**DEFENSE NUCLEAR FACILITIES  
SAFETY BOARD**

## Staff Report

June 26, 2019

### Safety Issues Relating to the Waste Isolation Pilot Plant Safety Significant Confinement Ventilation System

**Figure A-3.** Simplified diagram with potential CAM locations for the three cases evaluated.

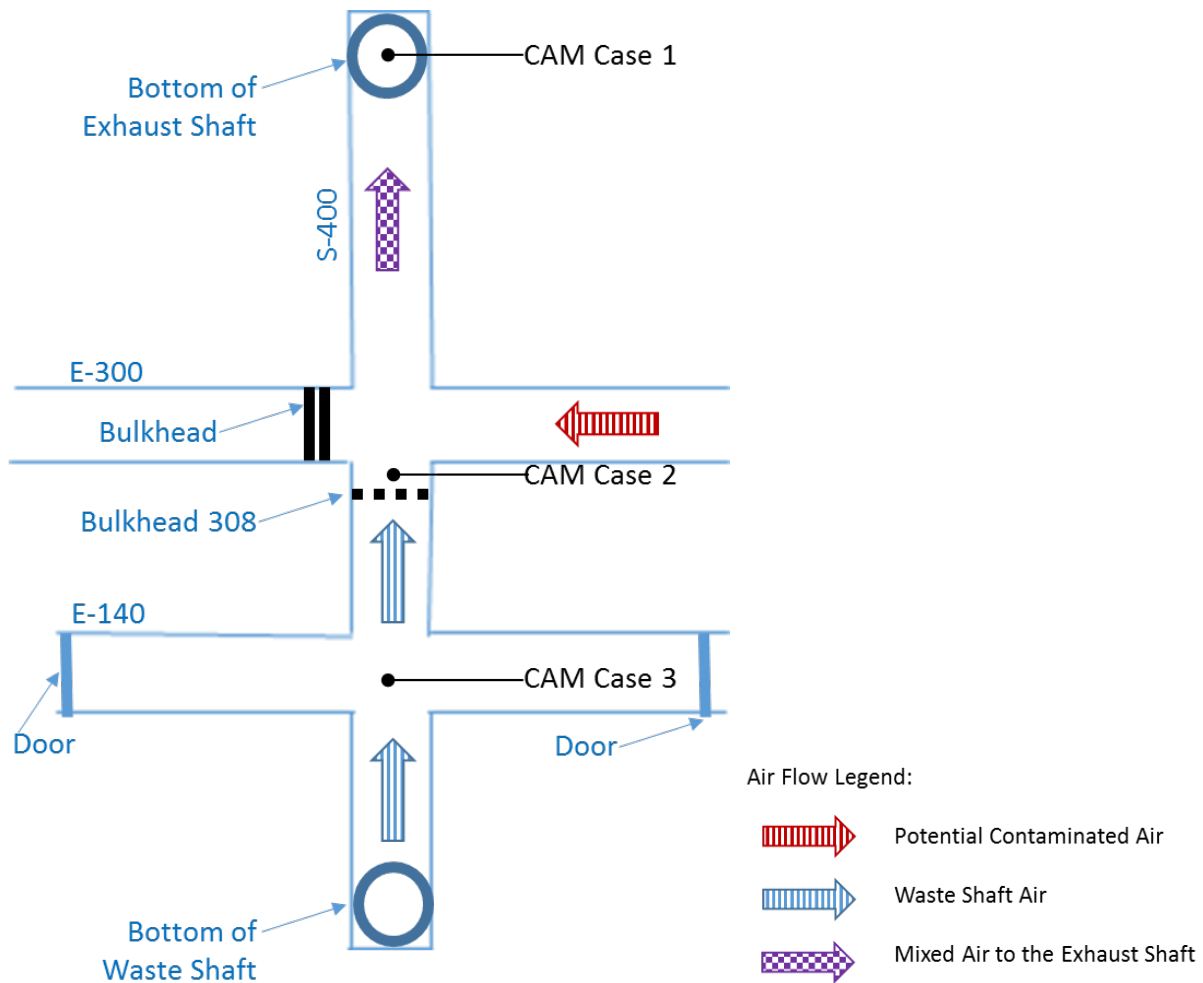
This analysis evaluates three cases. The radiological releases of the three scenarios evaluated take place in the underground waste shaft station located between the waste shaft and exhaust shaft. The Board's staff team selected this area due to the proximity of the waste shaft station to the bottom of the exhaust shaft. The three cases evaluate the following anticipated events at the waste shaft station and transport path: fire, deflagration/over pressurization, impact, and spontaneous combustion (e.g., CH/RH-UG-02-001a, CH/RH-UG-02-002a2, CH/RH-UG-02-002a3, CH-UG-01-001a2, CH-UG-06-001a, CH/RH-UG-10-003a, CH/RH-UG-01-005a1, CH/RH-UG-10-005a), when the underground ventilation system is credited as a mitigative control. The main differences between the three cases is the magnitude of the event and the location of the CAMs (see Figure A-3).

**First Case**—In the first case, the Board's staff team assumed that the anticipated event would be an explosion or high energy event of sufficient magnitude to push radiological contamination from the waste shaft station toward the exhaust shaft. The magnitude of this anticipated event would be similar to the design basis accidents (DBA), which contemplate a fuel operated vehicle and/or a vehicle carrying waste dropping from the waste shaft collar (i.e., CH/RH-UG-01-005a1 and CH/RH-UG-10-005a). This scenario assumed that CAMs would still work during and after the explosion and that any CAM located between the waste shaft and BH-308 would detect airborne contamination and send the signal to automatically start closing the isolation dampers. As illustrated in Figure A-3, BH-308 is located between the waste shaft and the exhaust shaft. However, BH-308 is not a safety component and for that reason it cannot be credited during these events. For this reason the Board's staff team also assumed that BH-308 is nonexistent and contamination is pushed almost instantaneously to the bottom of the exhaust shaft during this scenario. Thus there is no practical difference between detection times for any of the three potential CAM locations.

The second and third cases contemplate medium to low energy events without the potential to instantaneously push contamination to the bottom of the exhaust shaft. Instead, the contamination is detected at two different locations in the waste shaft station as described in the second and third cases.

**Second Case**—The second case assumed detection by a CAM located next to BH-308 and takes into consideration the distance between BH-308 and the bottom of the exhaust shaft. The cross-sectional area of the S-400 drift and maximum SSCVS volumetric flow rate are used to calculate the air stream velocity; factoring in the travel distance yields the transport time. This volumetric flow rate is used due to the short distance between BH-308 and drift E-300 (see Figure A-3). The Board’s staff team assumed that any radiological release detected in the vicinity of BH-308 accelerates almost immediately to the air stream velocity of the E-300 drift in the direction toward the exhaust shaft.

**Third Case**—The third case assumed detection by a CAM located at the intersection of the S-400 and E-140 drifts. This case takes into consideration the additional distance between the intersection and BH-308. Once again the air stream velocity is inversely proportional to the cross-sectional area of the flow path. In the third case, the smallest area and higher velocity is at the BH-308 dampers. The cross-sectional area at BH-308 also could fluctuate based on the damper free area<sup>1</sup>.

For cases 1, 2, and 3C, the transport time calculated is 41, 47, and 56 seconds, respectively. If the PDSA allows 60 seconds from detection to full closure of the SSCVS isolation dampers, the alignment of the ventilation system to a safe configuration that could filter the underground air will not happen on time and contaminated air could be released to the environment.

A radiological release detected at BH-308 or at the intersection of E-140 and S-400 has the potential to reach the first SRS isolation damper before it is completely closed. This could potentially cause a release of unfiltered radiologically contaminated air into the SRS building. The SRS building is not part of the safety significant confinement boundary, which increases the likelihood of leaking potentially contaminated air into the environment.

Figure A-4. Bulkhead 308 Front View

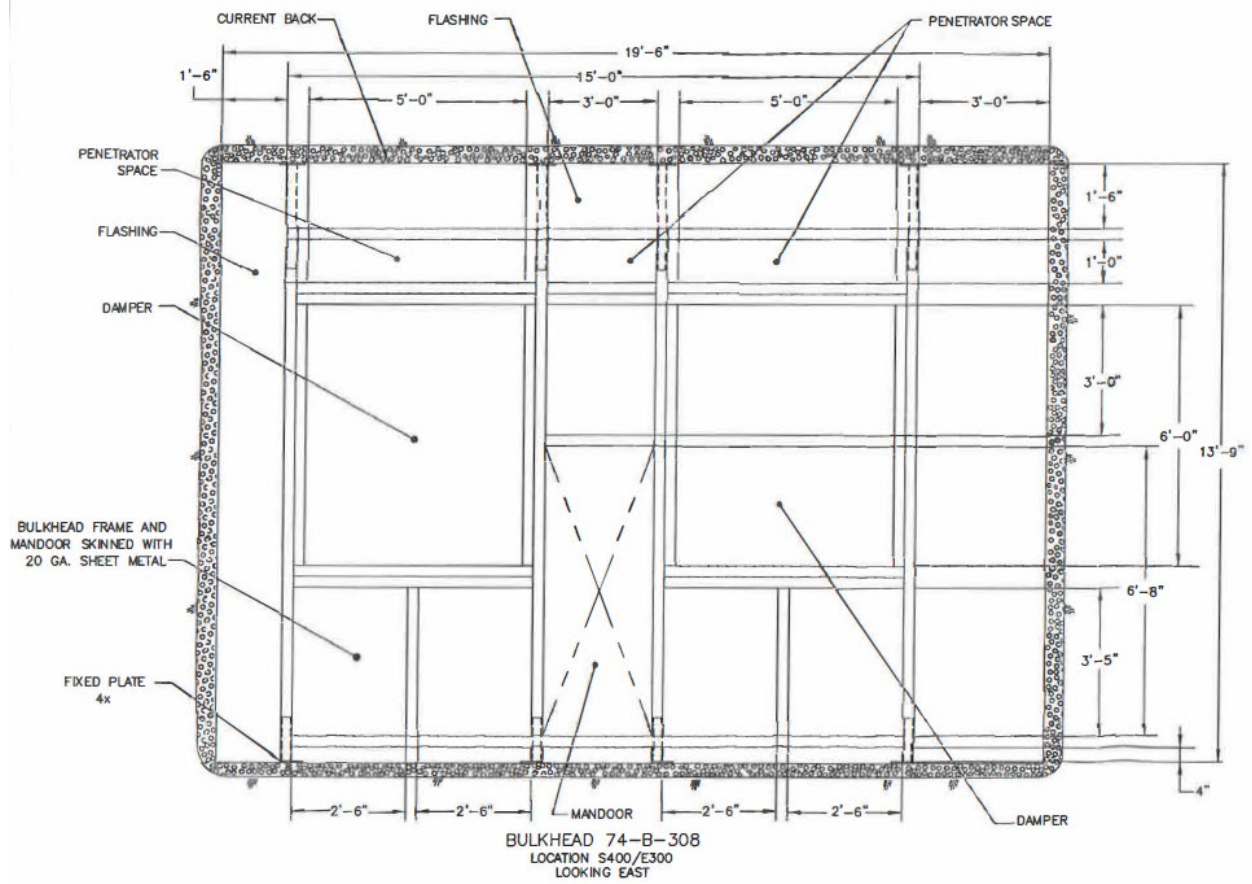
In this case, two main cross-sectional areas are used to calculate two different transport times. One area calculation uses the S-400 drift cross-sectional area and the second calculation uses the BH-308 damper cross-sectional area. The Board's staff team used the area of BH-308 as an approximation of S-400 drift cross-sectional area (Figure A-4). The dimensions of this area are 19'6" by 13'9" for an area of 268.13ft<sup>2</sup> [7]. Each BH-308 damper has dimensions of 5' by 6' for an area of 30ft<sup>2</sup> for a single damper and 60ft<sup>2</sup> for two dampers. However, assuming the damper blades occupied 50 percent of the area, the damper free area for the two dampers would be 30ft<sup>2</sup>. The volumetric flow rate of 25,000cfm, used between the intersection and BH-308 for this calculation, is the approximate target volumetric flow rate used to keep the differential pressure across BH-308 and the same flow rate used in the SRK transient time analysis [4] when BH-308 dampers are mostly open.

The maximum allowed volumetric air flow rate calculated for a 50 percent damper's cross sectional area is 17,000cfm, which is below the recommended 25,000cfm to maintain the required differential pressure at BH-308. Any flow rate above that value would increase the likelihood of contaminated air reaching the isolation damper before it is completely closed. This would cause a potential release of contaminated air to the environment.
